March 12, 2009
NND-09-0047

Subject: Virgil C. Summer Nuclear Station (VCSNS) Units 2 and 3 Combined License Application (COLA) - Docket Numbers 52-027 and 52-028 Response to NRC Request for Additional Information (RAI) Letter No. 030

Reference: Letter from Ravindra G. Joshi (NRC) to Alfred M. Paglia (SCE&G), Request for Additional Information Letter No. 030 Related to SRP Section 2.5.2 for the Virgil C. Summer Nuclear Station Units 2 and 3 Combined License Application, dated February 10, 2009.

Figure RAI-12A. Peak ground acceleration hazard curves for a site in southern California illustrating sensitivity to aleatory standard deviation (log 10 units). Reproduction of Figure 2-10 of Abrahamson and Bommer (2006).

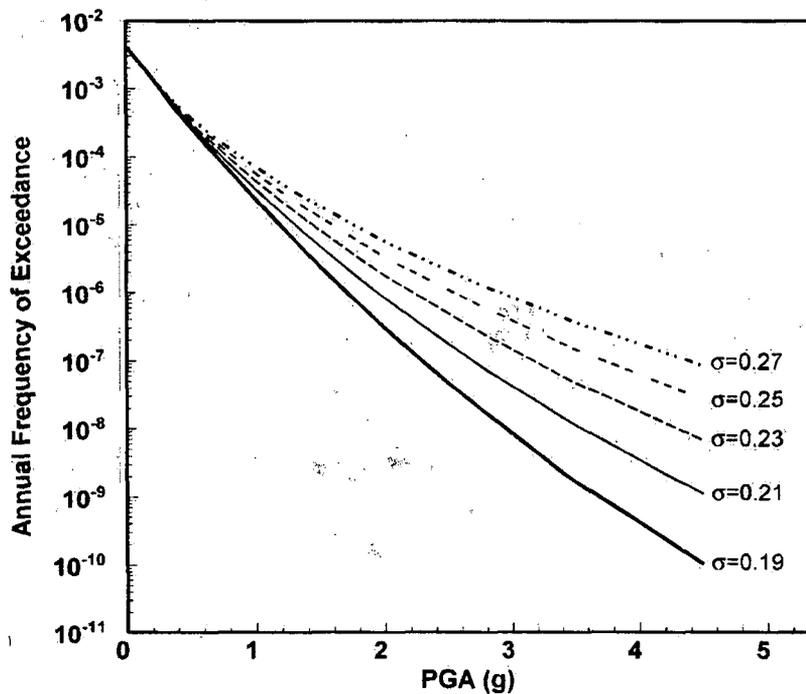
FSAR Section 2.5.2.4.5 (page 2.5.2-40) states that the applicant used the results of Abrahamson and Bommer (2006) to characterize aleatory uncertainties. Please discuss the effect of using the Abrahamson and Bommer (2006) uncertainties on the calculated hazard, as well as the differences between Abrahamson and Bommer (2006) and the EPRI (2004) study. Please also explain how the seismic hazard curves and the UHRS would change if the EPRI (2004) aleatory uncertainties had been used rather than those in Abrahamson and Bommer (2006).

The Abrahamson and Bommer (2006) ground motion aleatory uncertainties were used in the VCSNS FSAR because the original EPRI (2004) aleatory uncertainties were thought to be too large. Abrahamson and Bommer (2006, page 7-2) state: "The EPRI (2004) ground motion models were based on the JB distance metric and a significant increase in the standard deviation for JB distances less than 20 km was included in all of the sigma models developed in that study. The empirical ground motion data evaluated in this study do not support a large increase in the standard deviation at short distances, but some increase may be justified. Three alternative models of the additional contribution to the standard deviation at short distances are developed.....Note that most of the weight is given to the model with zero increase."

In addition to the short distance effect, two other effects were studied by Abrahamson and Bommer (2006). First, they found that the inter-event variability used by EPRI (2004) was conservative and adopted a different inter-event variability model. Second, Abrahamson and Bommer (2006) adopted an intra-event variability based on empirical data from the western US, rather than using modeling methods as in EPRI (2004). Both effects resulted in lower aleatory uncertainties.

Lower aleatory uncertainties in the ground motion equations will result in lower seismic hazard curves. For example, Figure RAI-12A (a reproduction of Figure 2-10 from Abrahamson and Bommer, 2006) shows peak ground acceleration seismic hazard curves for a site in southern California with a range of aleatory uncertainties in the ground motion equation. If the EPRI (2004) aleatory uncertainties had been used in the VCSNS seismic hazard analysis, the seismic hazard curves and UHRS for the Summer site would have been higher.

Figure RAI-13A. Ground motion model clusters, individual models, and weights recommended for general area sources (reproduced from Figure 5-2 of EPRI, 2004).

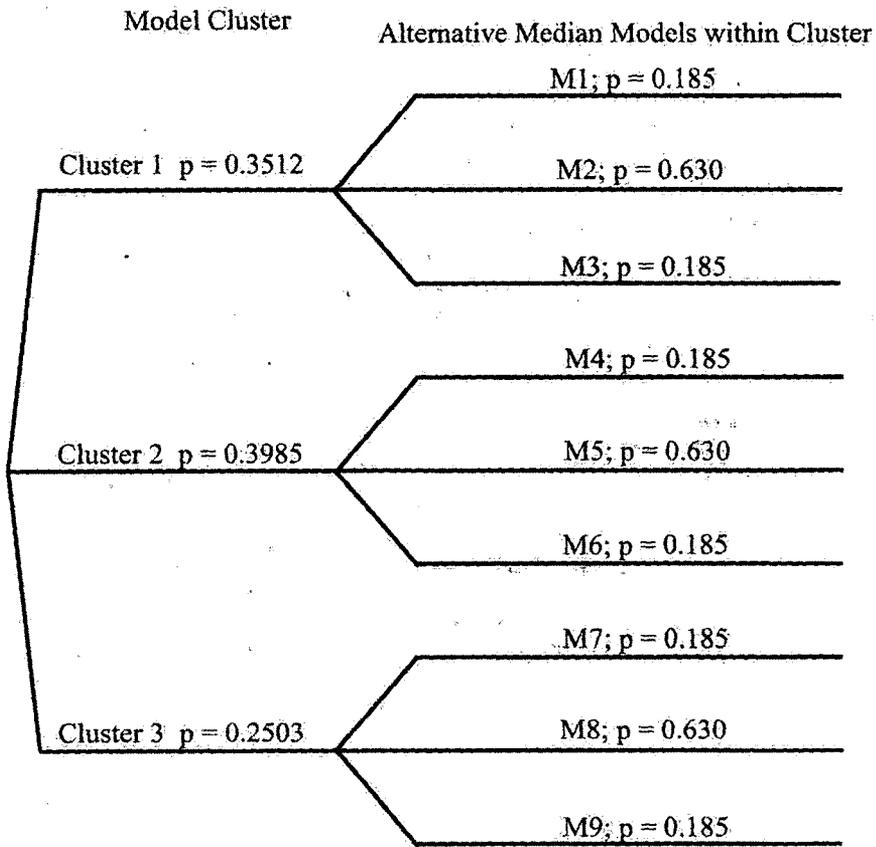
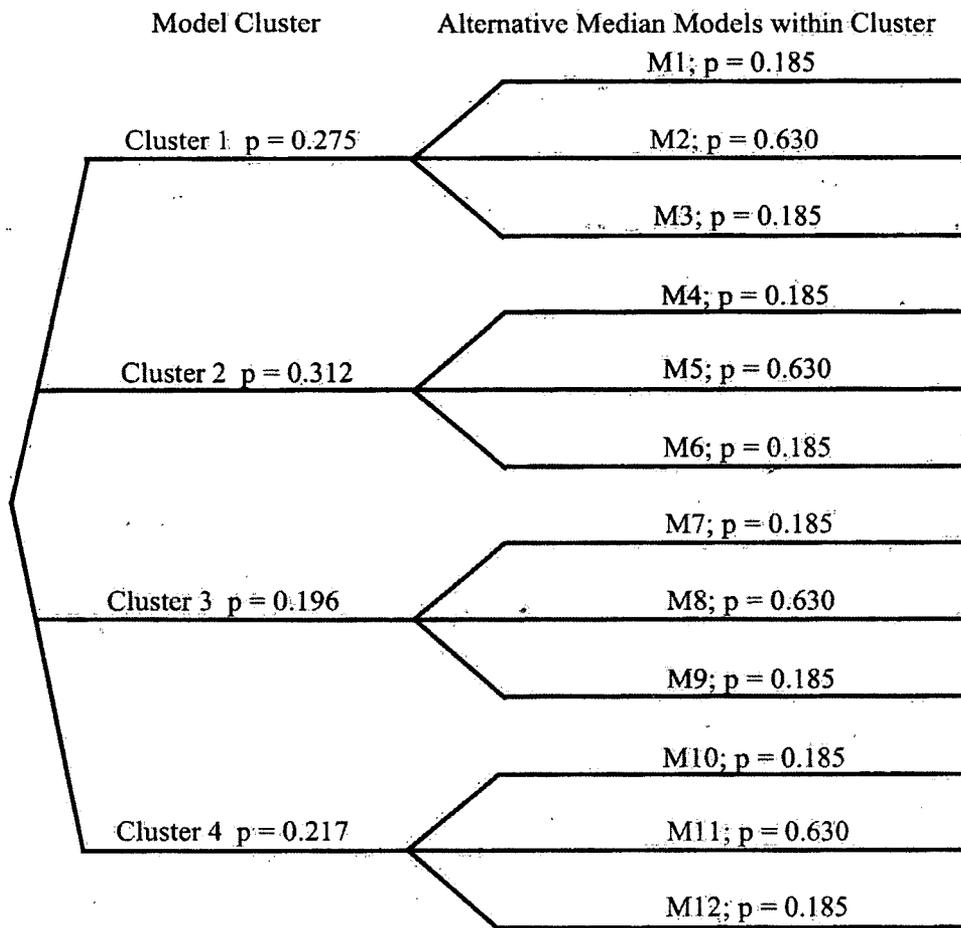
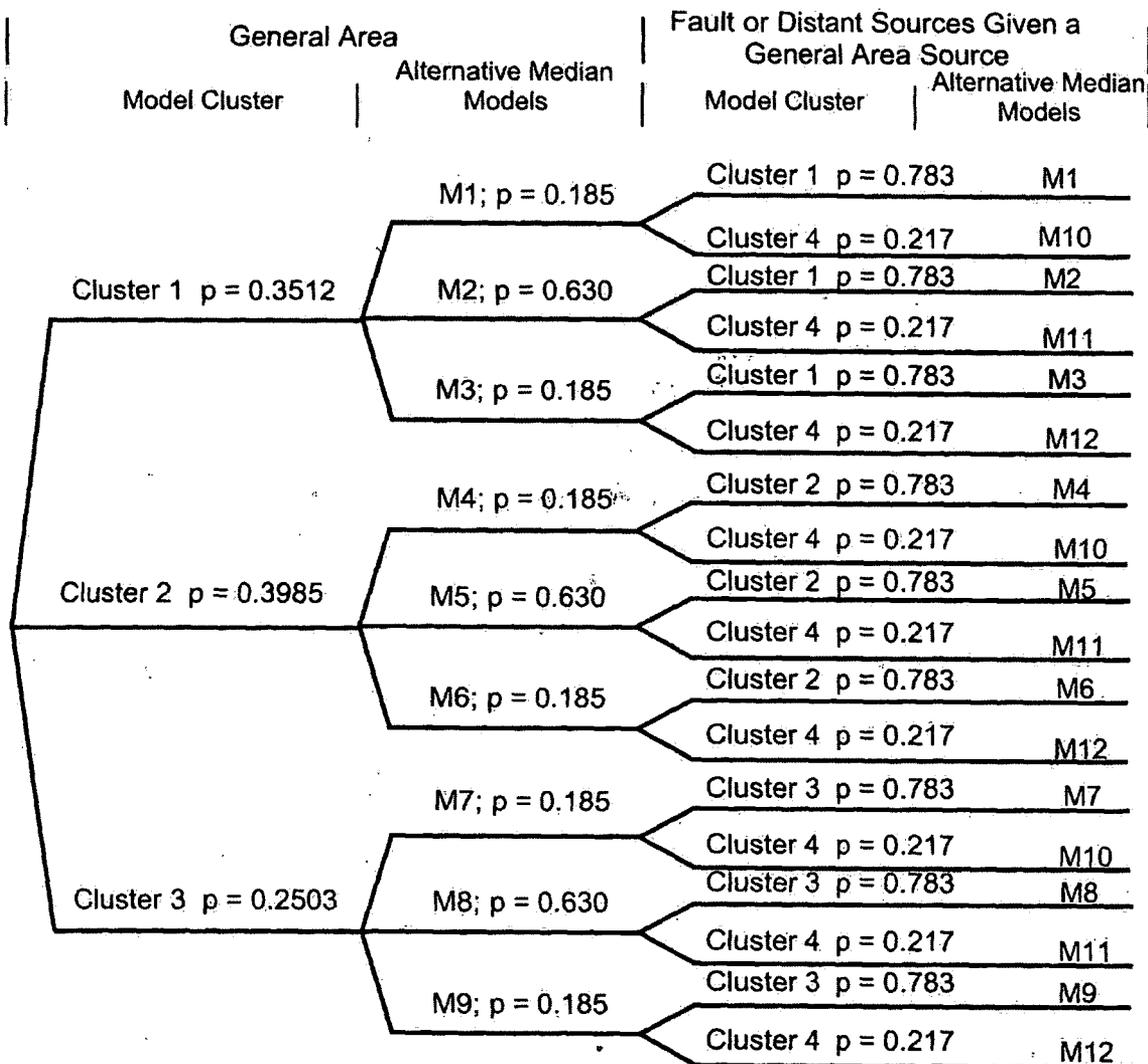
In FSAR Section 2.5.2.4.5 (page 2.5.2-40), the applicant stated that it used the EPRI (2004) ground motion equations in its updated PSHA. However, the EPRI ground motion report contains many equations that are arranged in “clusters.” Please provide more detail regarding how the applicant used the various equations from the EPRI ground motion report to compute the site hazard, including the weights that the applicant applied for the specific equations, if multiple equations were used in the analysis.

The EPRI (2004) ground motion equations consist of four clusters, each of which has a high, medium, and low estimate. Figure RAI-13A shows that for general area sources, only the first 3 clusters are used in the analysis. Figure RAI-13A indicates the weights on the nine equations used for general area sources. For non-general sources, Figure RAI-13B shows that all four clusters are used in the analysis, and Figure RAI-13B indicates the weights on the 12 equations used for non-general sources. When both general area sources and non-general sources are used in a hazard analysis, the nine equations shown in Figure RAI-13A and the 12 equations shown in Figure RAI-13B are used in a specific set of combinations, and these combinations (and their weights) are shown in Figure RAI-13C. Thus both the number of equations and their weights depend on the specific types of sources that are used for a seismic hazard analysis. The seismic hazard analysis for the Summer site used the weights given in EPRI (2004) for all clusters and all equations within a cluster.

Figure RAI-14A. 1 Hz spectral accelerations predicted for M=7 for the EPRI (2004) models and for the Atkinson and Boore (2006) and Tavakoli and Pezeshk (2005) references.

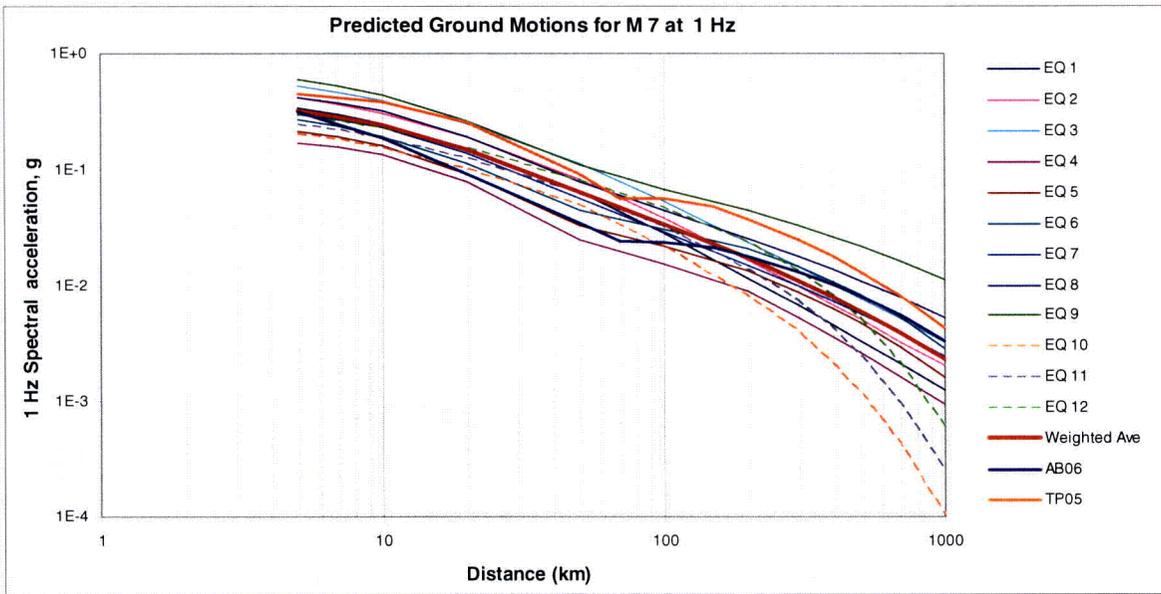
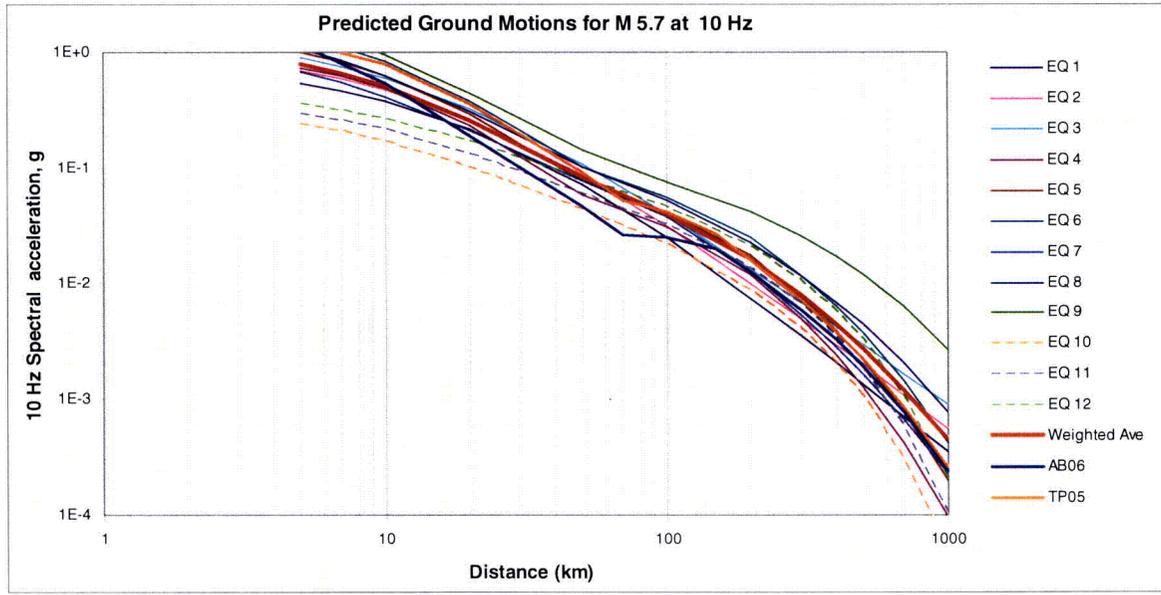
NUREG-0800 states that use of the EPRI ground motion models (2004) “is acceptable as long as an adequate investigation has been carried out to provide reasonable assurance that there are no significant updates or new models that may impact on the results of the PSHA.” Section 2.5.2.4.5 of the FSAR does not discuss any new ground motion models. However, at least two new ground motion prediction models for the CEUS have been published in peer-reviewed literature since 2004: (1) “Empirical-stochastic ground-motion prediction for eastern North America” by Tavakoli and Pezeshk (Bulletin of the Seismological Society of America, 2005, v.95[6], 2,283-2,296) and (2) “Earthquake ground-motion prediction equations for eastern North America” by Atkinson and Boore (Bulletin of the Seismological Society of America, 2006, v.96[6], 2,181-2,205). In addition to these specific models, the latest version of the US National Seismic Hazard maps (Petersen and others, 2008) computes ground motions from a weighted combination of a number of ground-motion prediction equations. As such, these ground motions can be considered another ground-motion model. Please provide justification for not considering these new ground-motion prediction models.

Figure RAI-14A plots ground motion amplitudes for 1 Hz spectral acceleration for $M=7$ earthquakes vs distance for the 12 equations used from EPRI (2004), and for the Tavakoli and Pezishk (2005) and Atkinson and Boore (2006) references. At all distances, the range of the 12 EPRI (2004) models encompasses the ground motions predicted by the other two references.

Figure RAI-14B shows a similar plot of ground motion amplitudes for 10 Hz spectral acceleration for $M=5.7$. At all distances, the range of the 12 EPRI (2004) models encompasses the ground motions predicted by the other two references, except for distances between about 50 and 90 km, where the Atkinson and Boore (2006) equation falls below the range of the 12 EPRI (2004) models.

Among these nine, the Atkinson and Boore (1995), Toro et al (1997), Campbell (2003), Frankel et al. (1996), Somerville (2001), and Silva et al (2002) equations were considered in the EPRI (2004) study that was used in the seismic hazard calculations for the Summer site. The Toro (2002) reference is an update of the Toro et al (1997) reference for close distances to large magnitude earthquakes. The Atkinson and Boore (2006) and Tavakoli and Pezeshk (2005) references are evaluated above and are encompassed by the range of EPRI (2004) ground motion equations. Thus the weighting of the nine equations in the Peterson et al. (2008) study does not constitute an independent ground motion model, but involves a weighting of many of the equations used in the EPRI (2004) study, and includes some models (e.g. Frankel, et al., 1996) that have not undergone peer review. The two more recent equations, published since the EPRI (2004) study, are consistent with the EPRI (2004) study. Thus the EPRI (2004) ground motion equations are considered representative of those used by the Peterson et al. (2008) study. Further, the EPRI (2004) study consisted of a SSHAC level 3 study (Senior Seismic Hazard Analysis Committee, 1997) to derive appropriate ground motion models for the central and eastern US, and this the EPRI (2004) study has a level of credibility appropriate for seismic hazard calculations for nuclear facilities. In addition, Drs. Atkinson, Campbell, Silva, Somerville, and Toro participated as experts in the EPRI (2004) study.
